Date 08.10.2024
 Project No 22026
 Client Jimmy and Mel Campbell
 90 Harbord Rd Freshwater 2096

Re: 90 Harbord Rd – Walls on boundary

A development application is being prepared for a detached dual occupancy on the property at 90 Harbord Road. As part of the new development it is proposed to retain some existing walls of original buildings. SRHA Has undertaken a structural review of the walls slated for retention.

Fig.1. Ground Floor plan – Part SK100

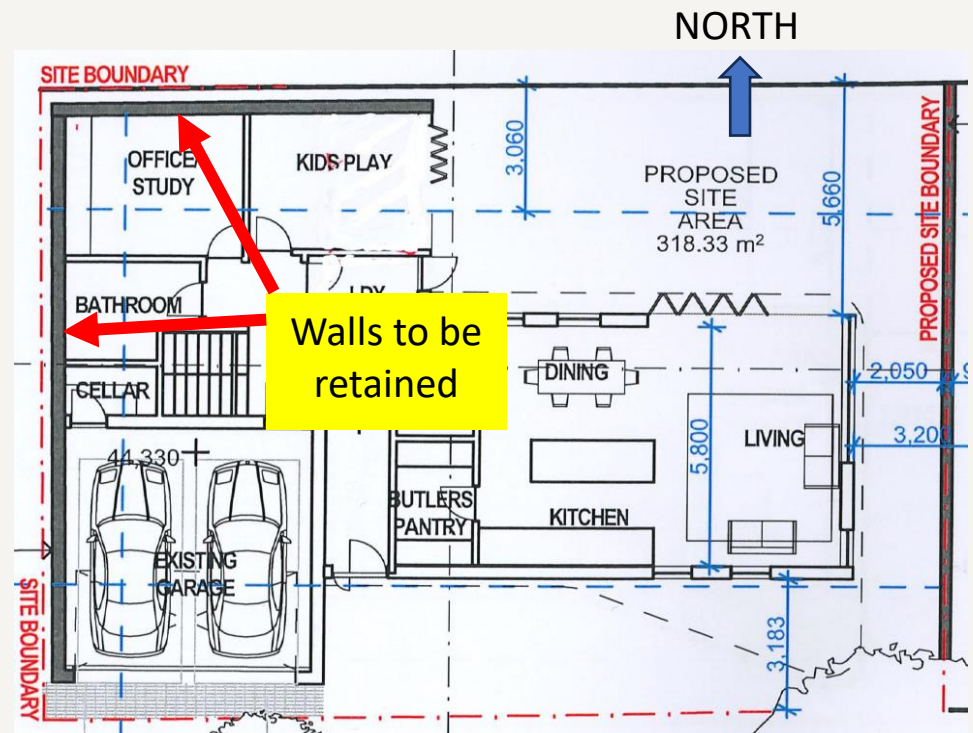
Indicated on this plan are two walls proposed to be retained. These walls sit within a few hundred millimetres of the north and west boundaries of the property.

The DA documents show that proposed new Level 1 floors above are to be set in from the north and west boundaries by at least 1500mm.

The two existing boundary brick walls appear structurally sound. If the existing garage remained in action, these two walls might be expected to continue to provide sound support in their current configuration.

The proposed modifications as part of the DA dual occupancy proposal may add additional load to the subject existing boundary brick walls. However the offset of Level 1, plus new internal ground floor walls will mean this load increase is limited. It is our assessment that the existing brick walls will have adequate design capacity to support the new loads.

SRHA conclude that the observed structural condition of the north and west garage brick walls permits their retention. From our visual observations, the brickwork in the walls, its current condition, and the assumed founding likely arrangements for the walls are all structurally adequate to allow the existing walls to be incorporated into the proposed new building.
